Subject: Virgil C. Summer Nuclear Station  
Docket No. 50/395  
Operating License No. NPF-12  
Technical Specification Change  
VANTAGE 5 Fuel

ATTACHMENT

This attachment contains marked-up pages for the environmental consequence sections of Chapter 15 of the FSAR as summarized below.

Figure 15.4-61

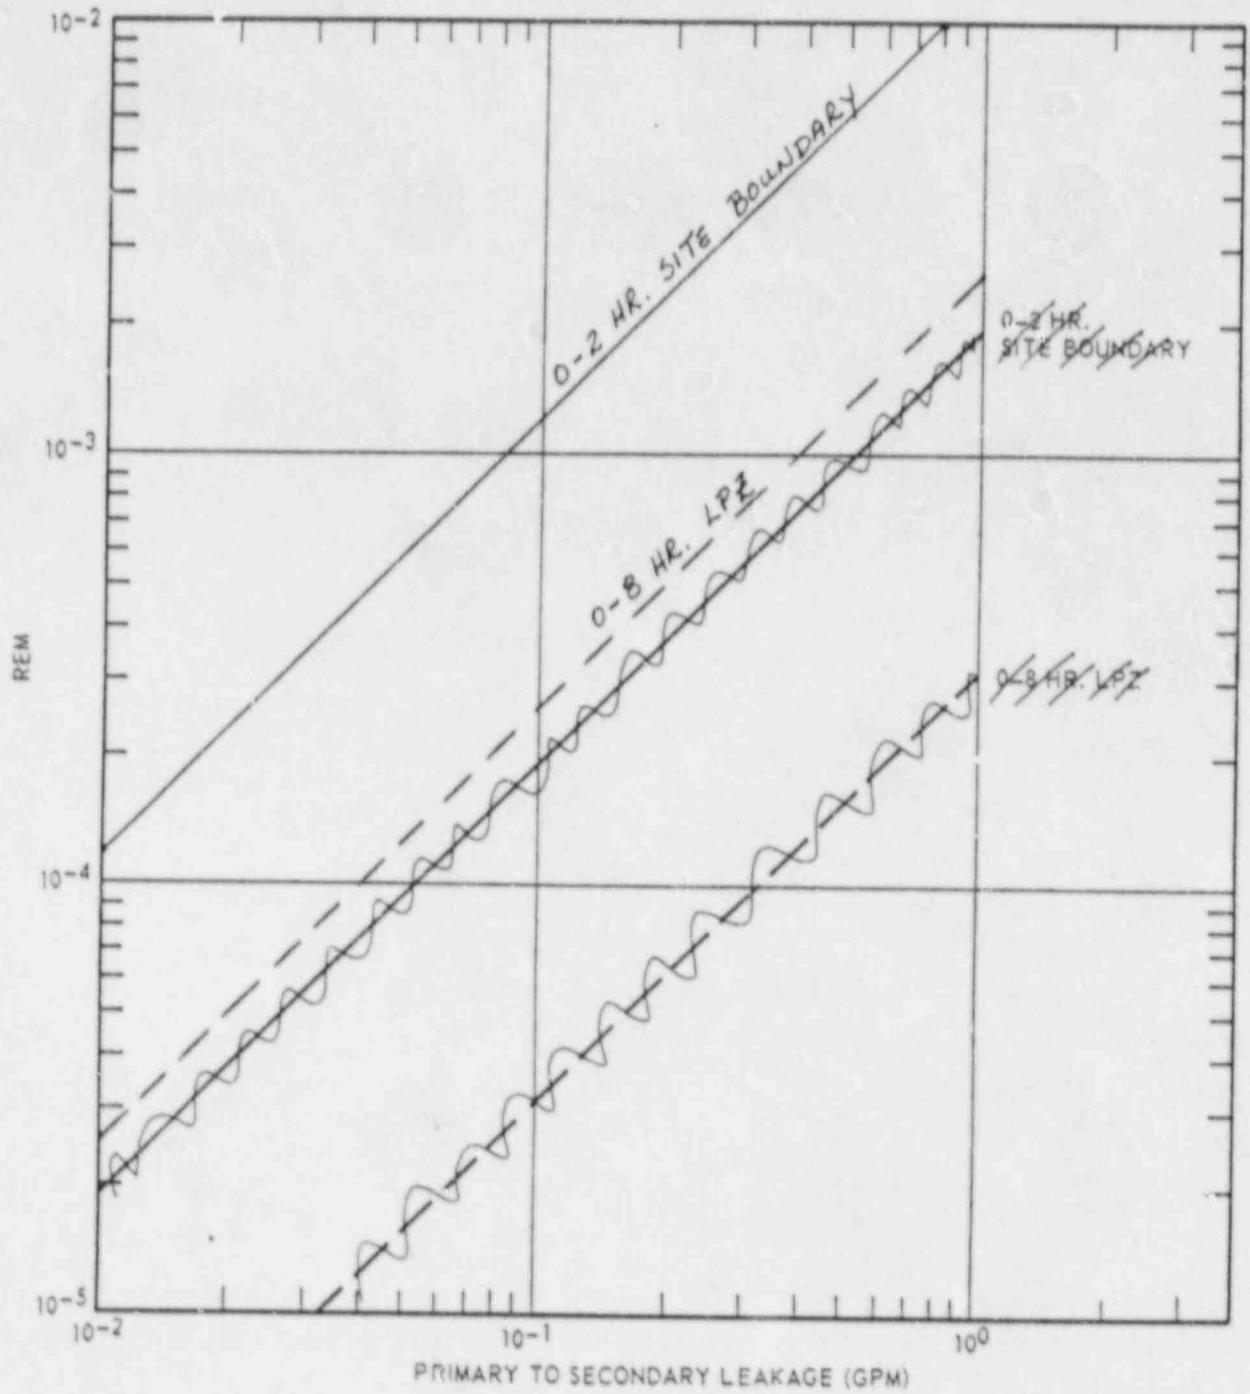
Gamma, beta and thyroid doses at the site boundary and at the low population zone for the steam line break accident, based upon the conservative analysis, are given by Figures 15.4-61 through 15.4-63 as a function of primary to secondary leak rate. The doses resulting from this accident are well within the limits defined by 10 CFR 100 (25 Rem, whole body; 300 Rem, thyroid) for the range of credible steam generator tube leakage.

Steam Generator Tube Rupture  
 Surface Body Gamma Dose  
 CONSERVATIVE CASE  
 Figure 15.4-66

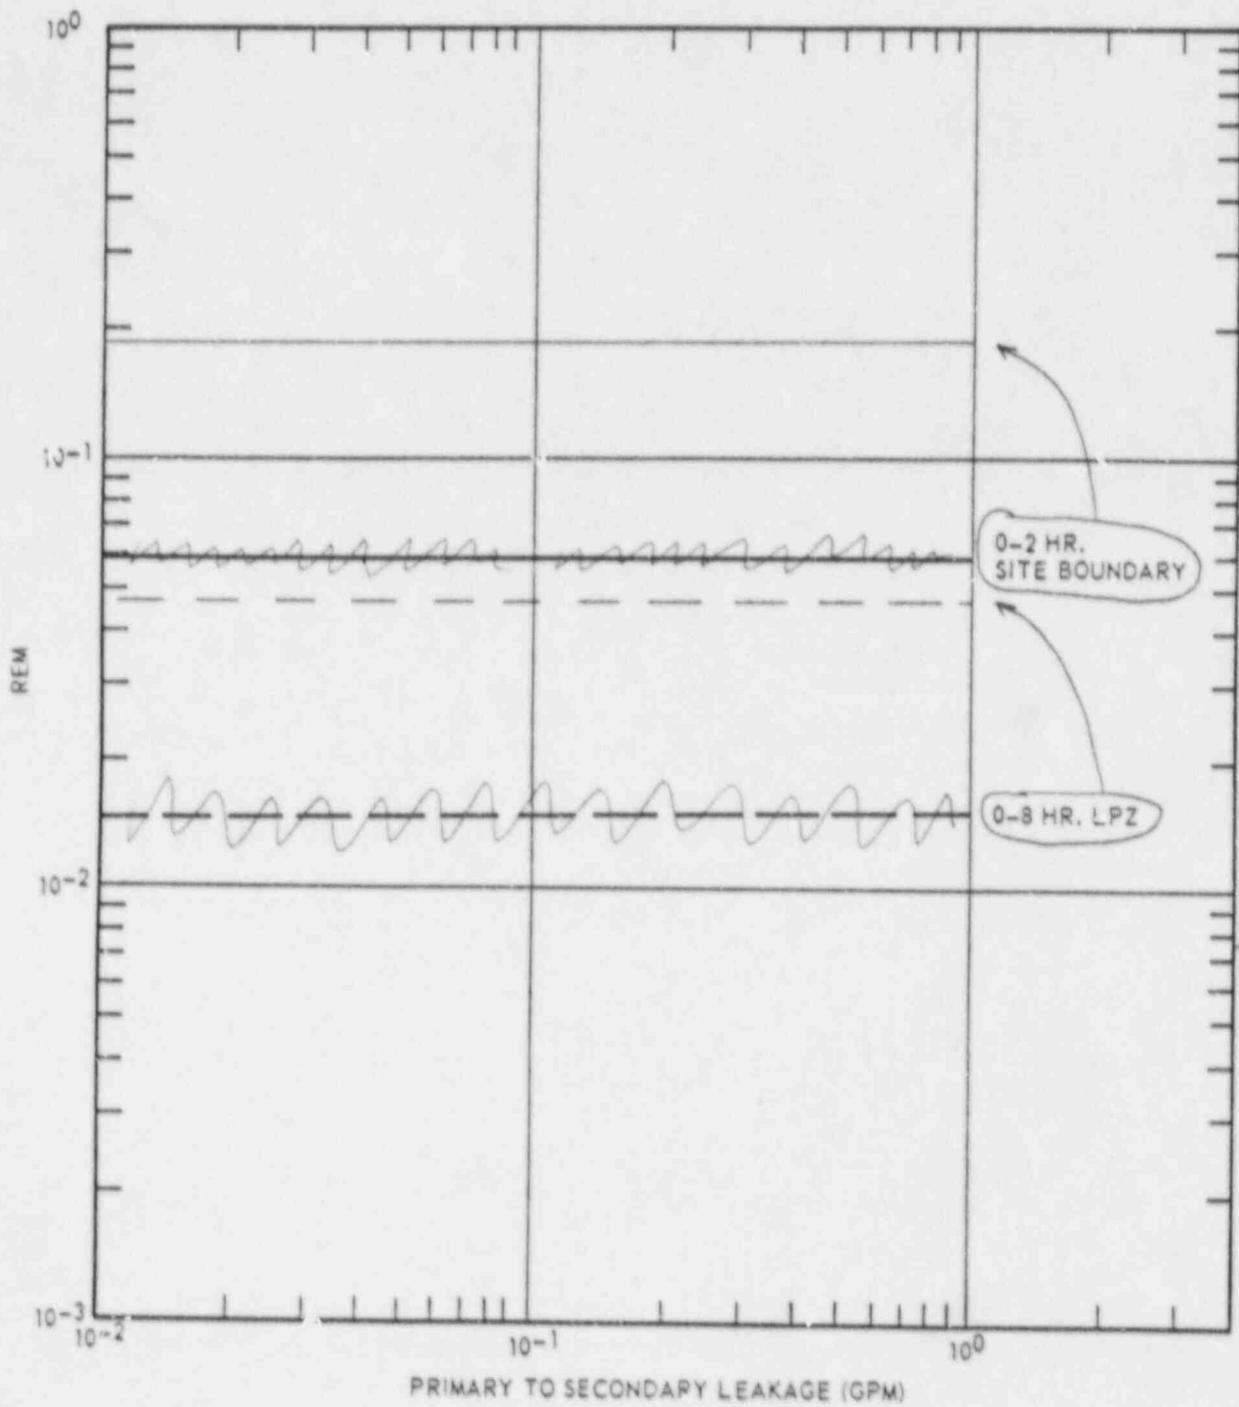
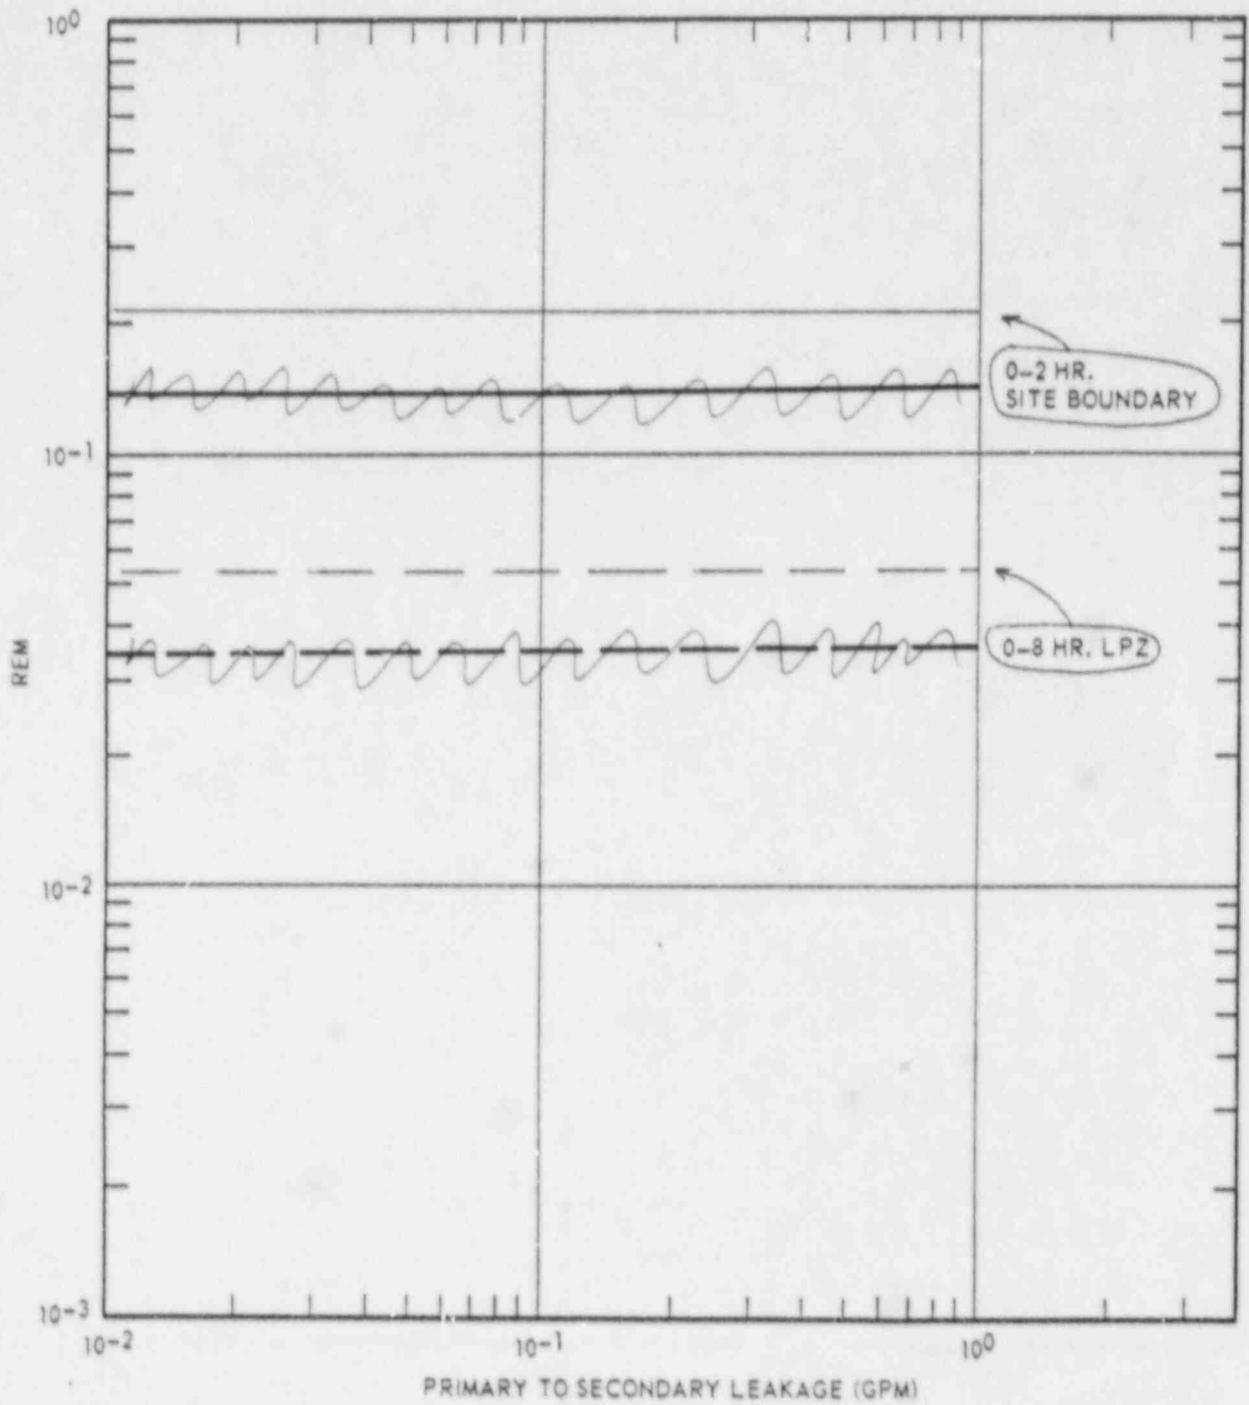
Gamma, beta and thyroid doses at the site boundary and low population zone resulting from the postulated steam generator tube rupture accident and based upon the conservative analysis as a function of primary to secondary leak rate are given by Figures 15.4-67 through 15.4-68. The doses from this accident are well within the limits defined in 10 CFR 100 (25 Rem, whole body, 300 Rem, thyroid) for the range of credible steam generator tube leakage.

Figure 15.4-77a

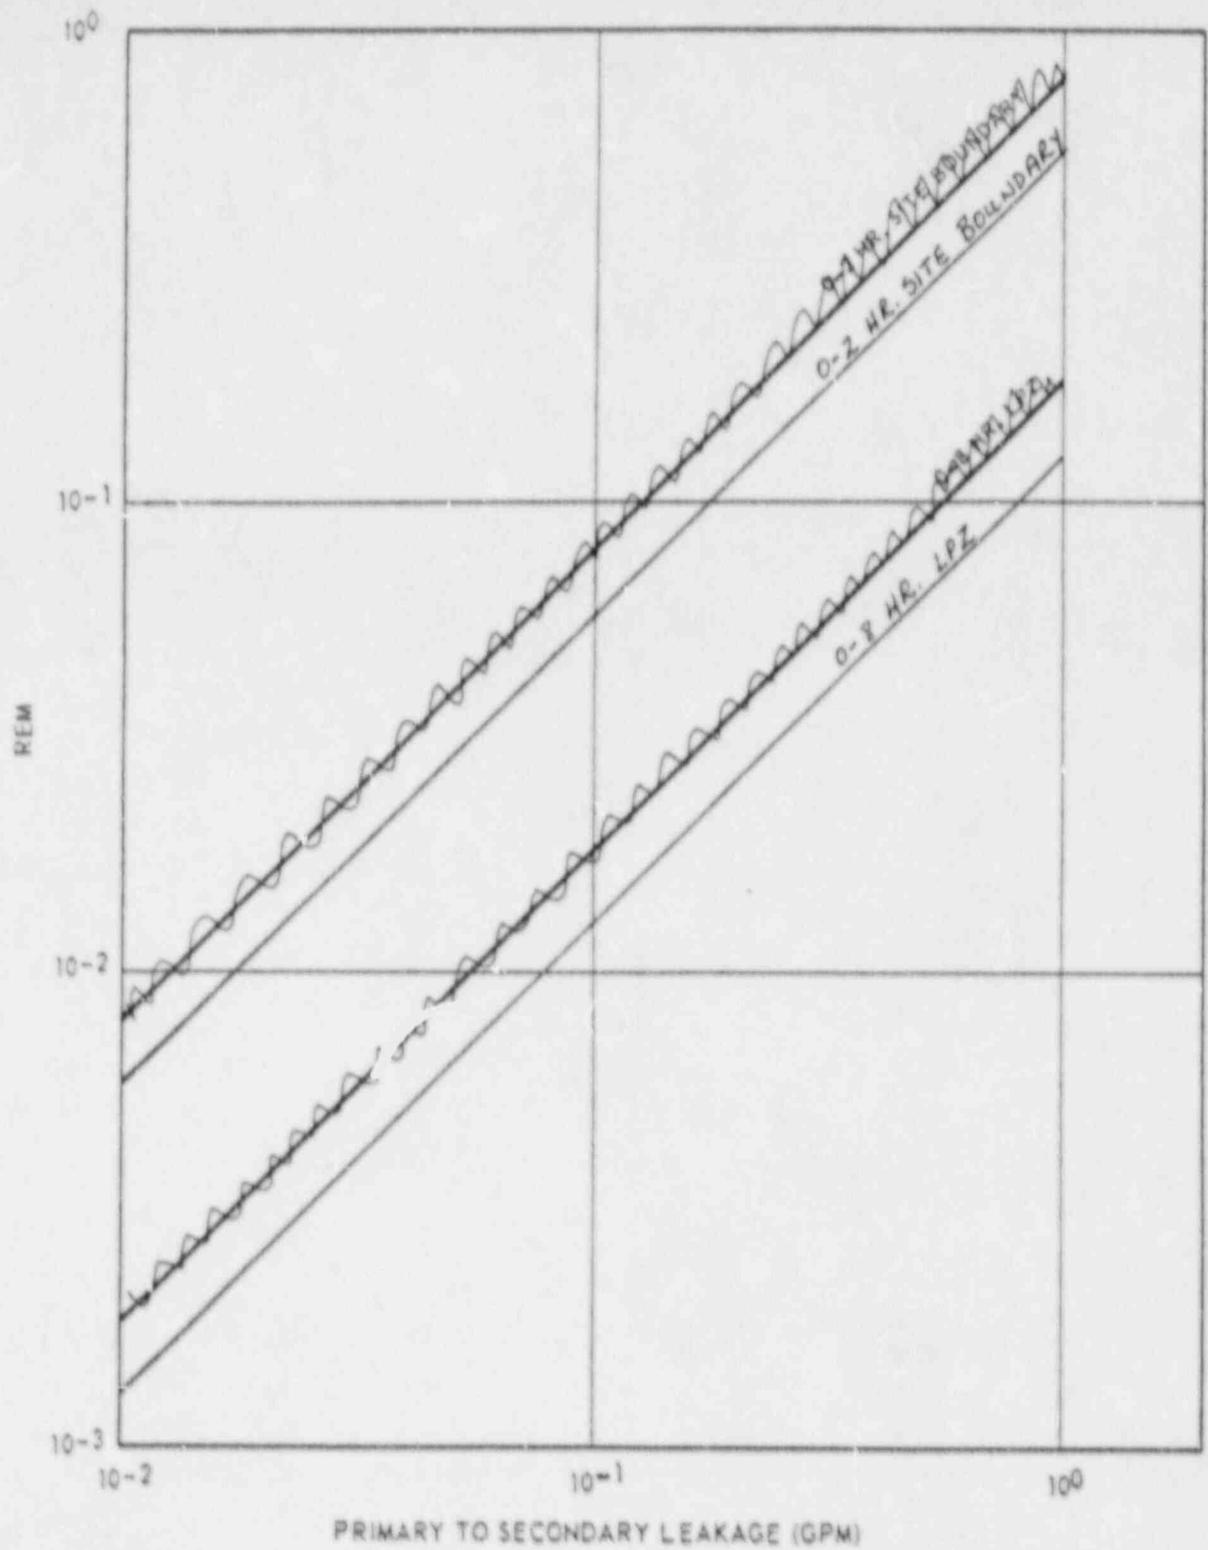
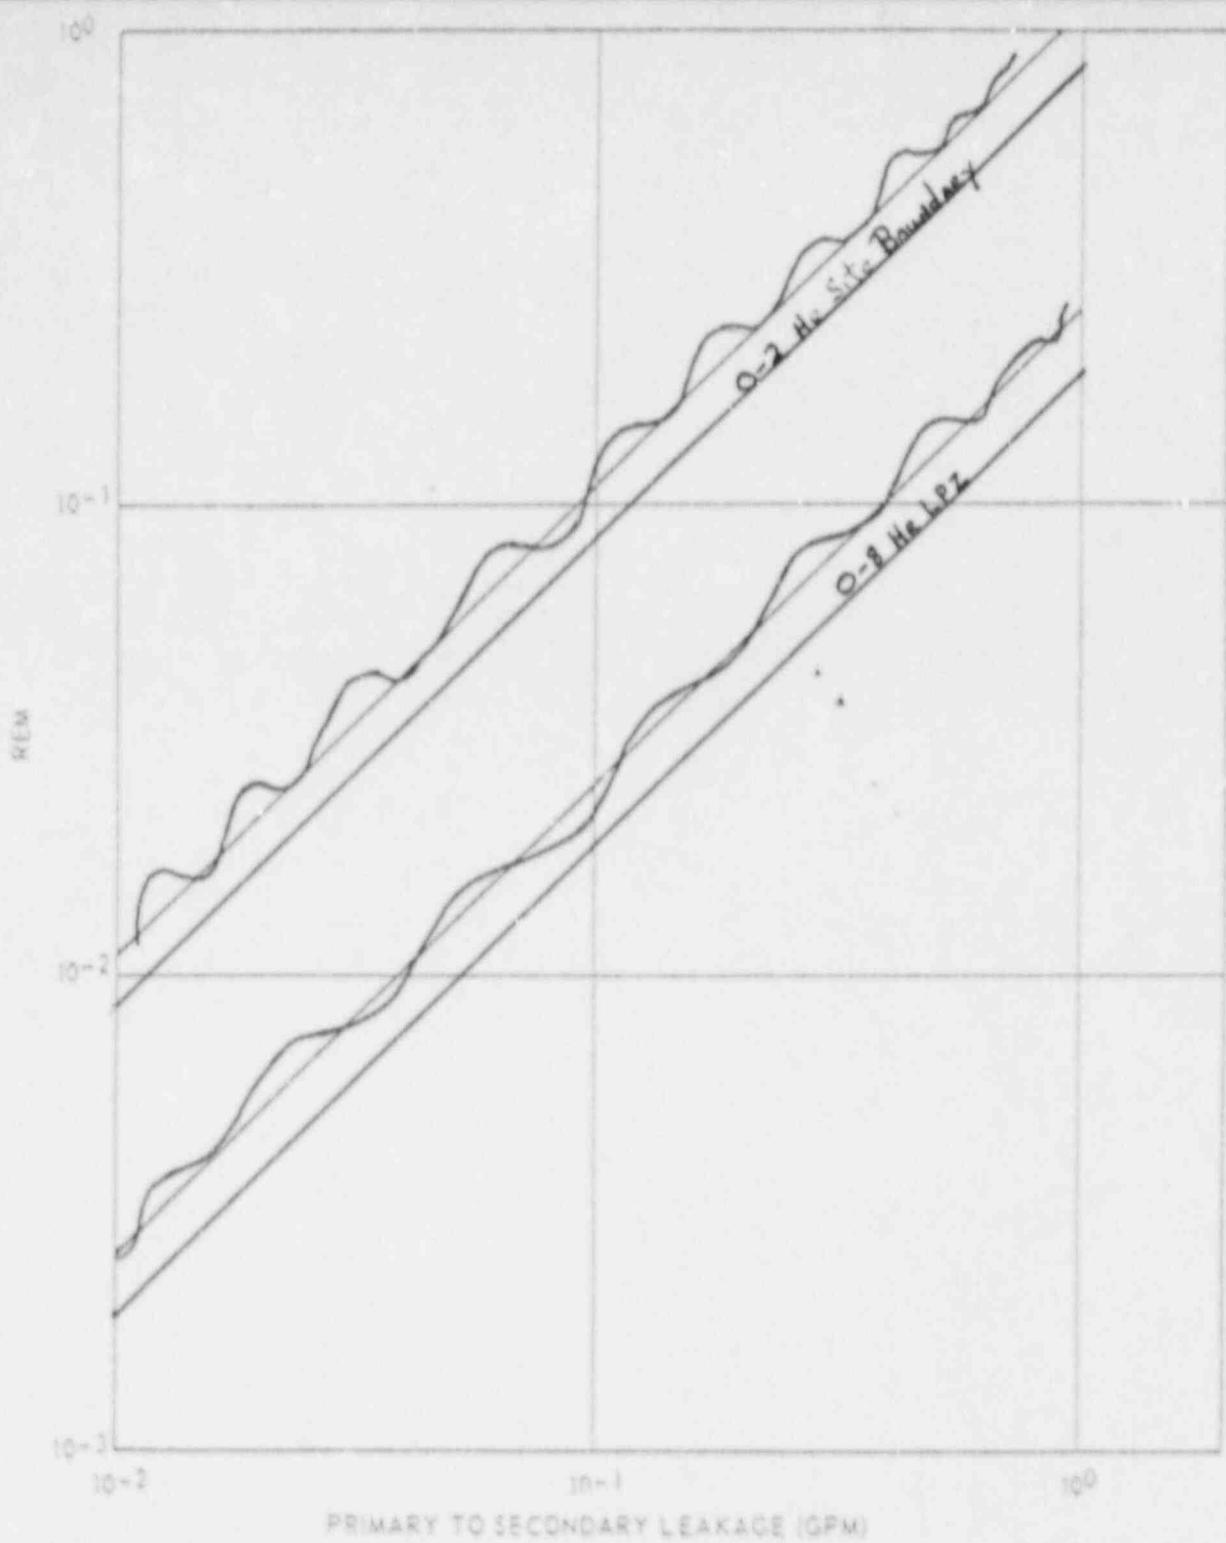
Gamma, beta and thyroid doses at the site boundary and at the low population zone for the reactor coolant pump locked rotor accident, based upon the conservative analysis, are given by Figures 15.4-77a through 15.4-77c as a function of primary to secondary leak rate. The doses resulting from this accident are well within the limits defined by 10 CFR 100 (25 Rem, whole body; 300 Rem, thyroid) for the range of credible steam generator tube leakage.
